Our Ref: CD/FSSD/12/02/03/01

LIFT RESCUE PROVISIONS

FIRE SAFETY REQUIREMENTS FOR LIFT RESCUE

FSR 5:2010

Illustration 5 : Rescue Hook

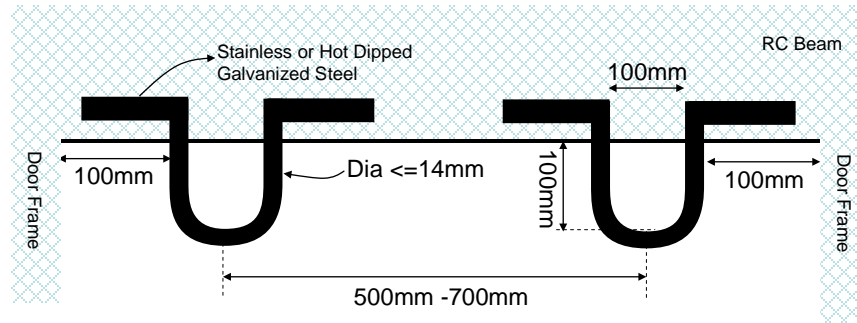
- 3.1.3 Each rescue hook shall have pull-out strength of not less than 1000 kg (10 kN) and a thickness of not more than 14 mm in diameter. The clear space between the hook and the emergency door frame shall not be less than 100 mm and the spacing between the two hooks shall be between 500 to 700 mm.

Illustration 8 : Car emergency doors-Deployment of bridging plate

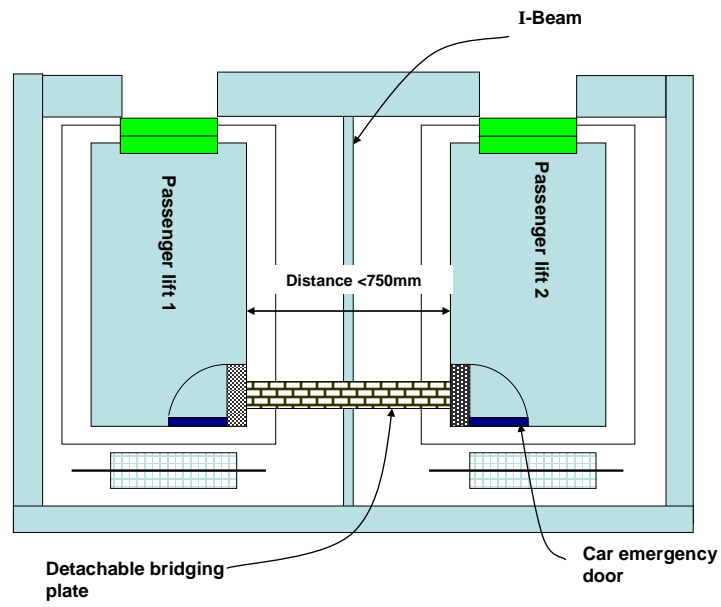
- (f) A set of detachable bridging plate and handrail, painted in bright yellow colour, shall be provided and secured to each emergency door. The plate shall have an anti-slip surface and means shall be provided to prevent accidental dropping of the plate and handrail into the lift well during deployment.

- (g) The detachable bridging plate shall have a minimum loading capacity of 200 kg and shall not weigh more than 10 kg. The maximum loading capacity shall be clearly marked on the top-face of the plate. Means shall be provided to prevent the plate and handrail from slipping off when deployed.
